For Decision

To determine a proposed modification to the approval for the Mangoola Coal Project.

The Mangoola Coal Project is located near Wybong in the Upper Hunter Valley (see Figure 1). The project was approved by the Minister on 7 June 2007, at which time it was known as the "Anvil Hill Coal Project".

Figure 4: Potentially noise affected residences

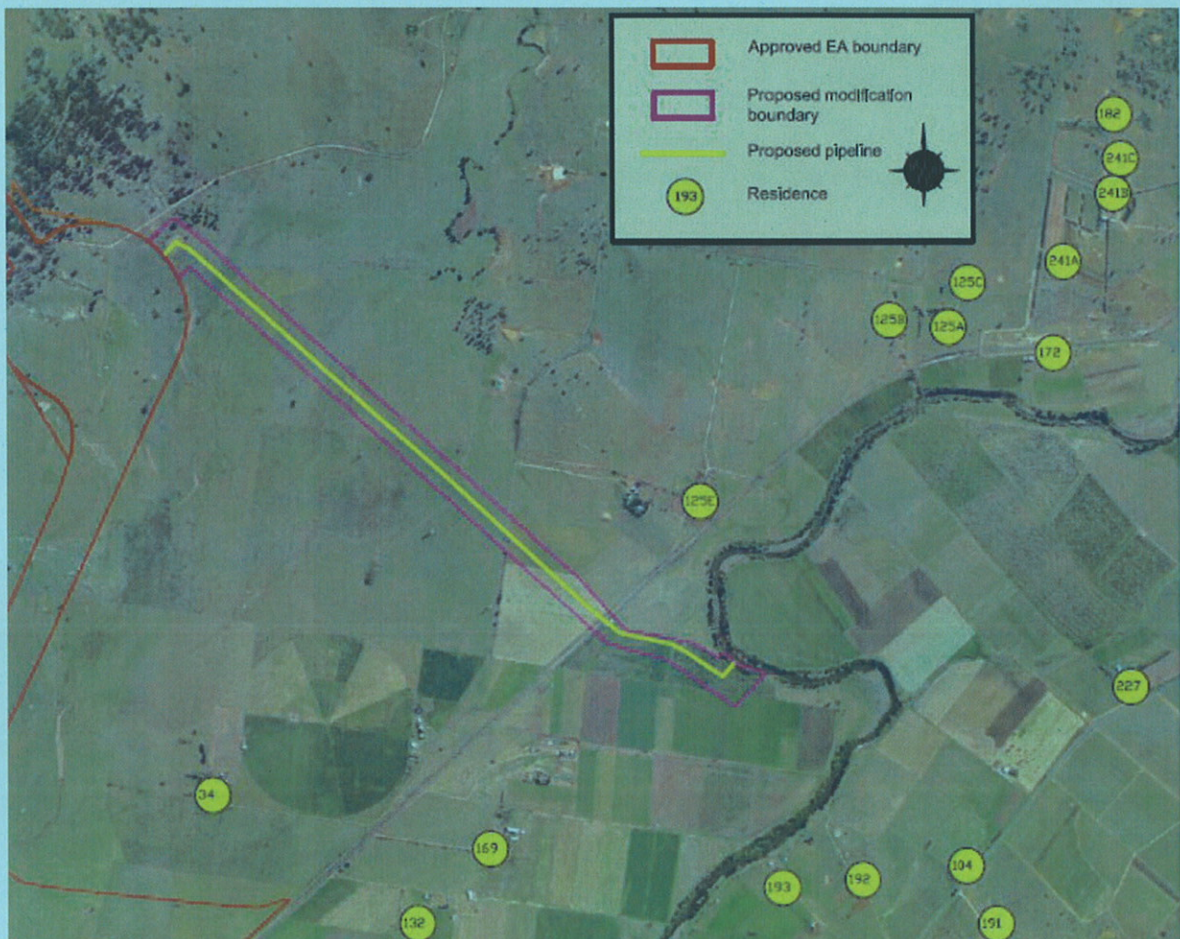
The results of the modelling suggest that up to five residences (designated in Figure 4 below as 192, 193, 125A, 125B and 125E) would exceed this criterion at certain stages of construction. Of these residences, 125E and 192 are predicted to exceed the criterion by up to 13dB and 6dB respectively, while the remaining three residences are predicted to exceed the criterion by between 1-5dB. All of these residences have previously been identified as being within the 'noise management' zone for the project, and are already entitled to have noise mitigation measures installed at their properties.

Given these existing noise mitigation entitlements, the temporary nature of the exceedances and the fact that they would only occur during designated daytime construction hours, the Department is satisfied that they would be justified for their short-term duration.
